CONSTRUCTION COMMITTEE MEETING AGENDA

DATE: **Tuesday, June 18, 2024**
TIME: **9:00 a.m.**
PLACE: **Carl T. Langford Board Room, Orlando International Airport, One Jeff Fuqua Blvd., Orlando, FL 32827**

CONSTRUCTION COMMITTEE MEETING
CHANGE ORDER AGENDA
Tuesday, June 18, 2024

AIRFIELD LIGHTING CIRCUITING PLAN (SHEET 9 OF 15)

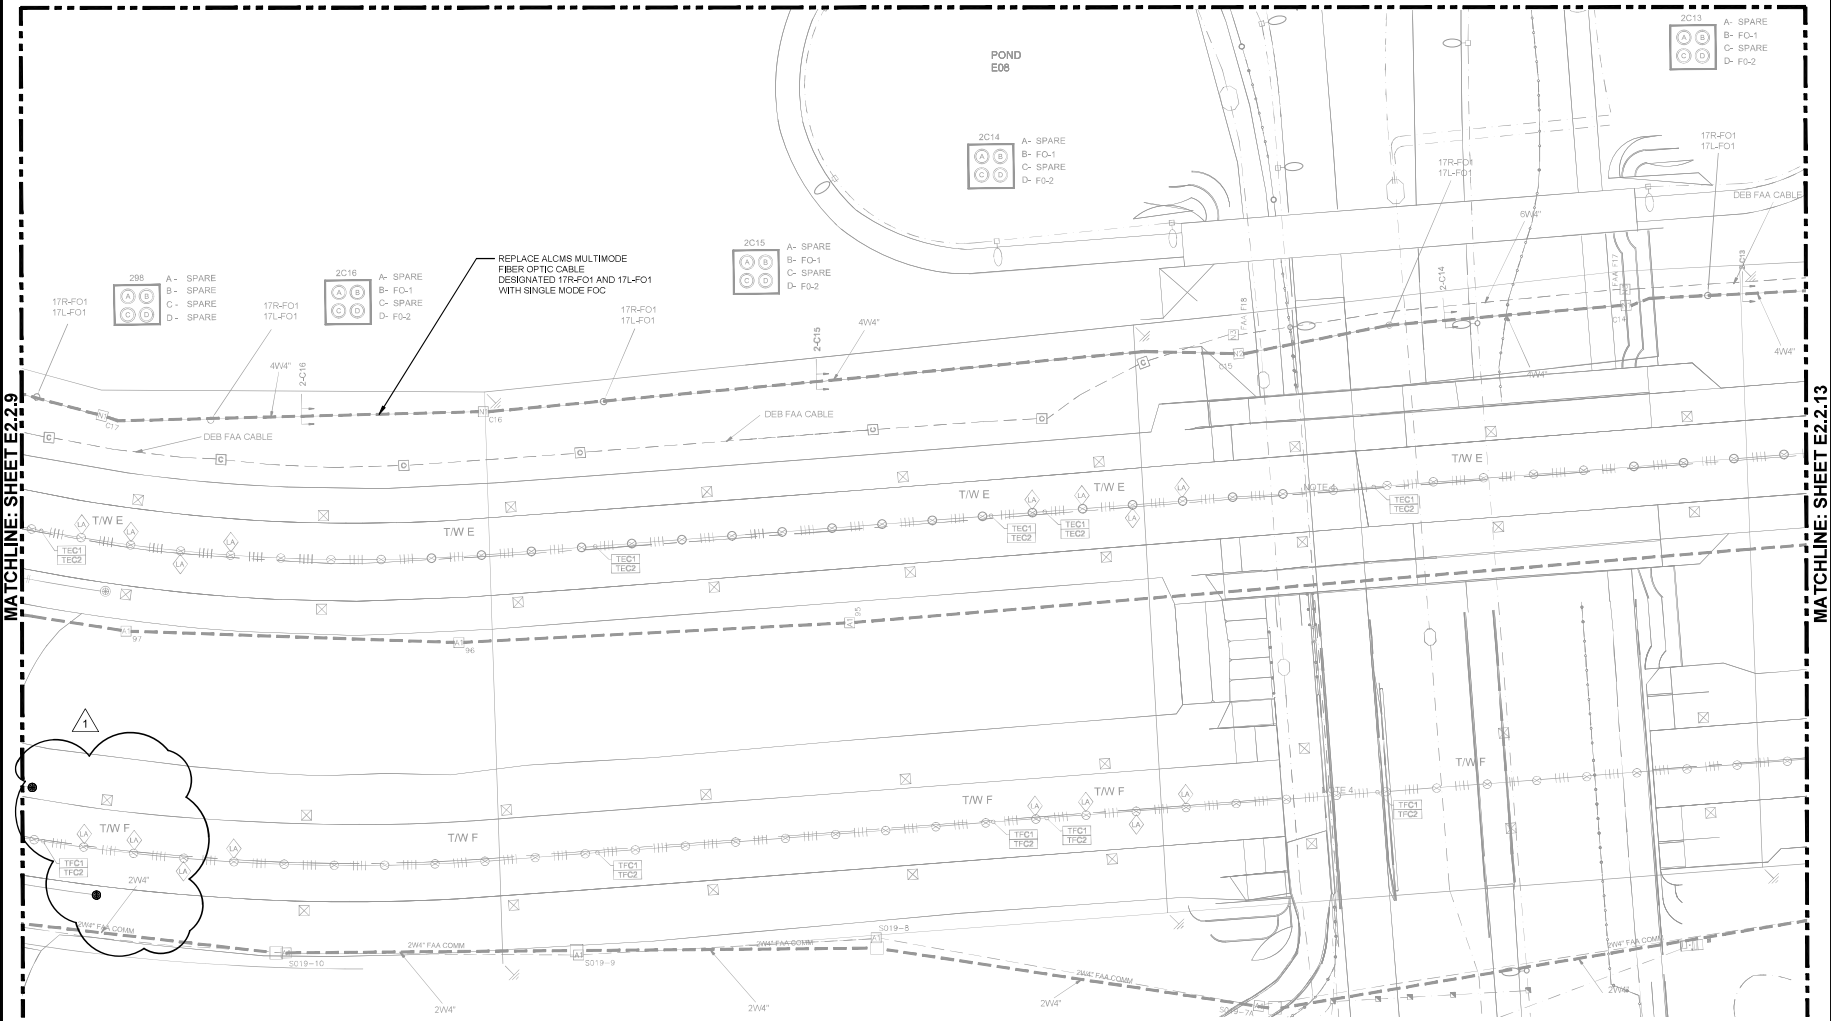
Description:
Eight Red Semiflush Taxiway Edge Fixture and one sign have been added to the scope of work. The lights will be installed on existing base cans and the sign installed on existing concrete pad. The following plan sheets have been revised: ED2.0.9, ED2.0.12, E.2.1.9, E2.2.9, E2.2.12, and E7.0.4.

Attachments:
The following sheets have been revised and are attached to this ESI #1: ED2.0.9, ED2.0.12, E.2.1.9, E2.2.9, E2.2.12, and E7.0.4.
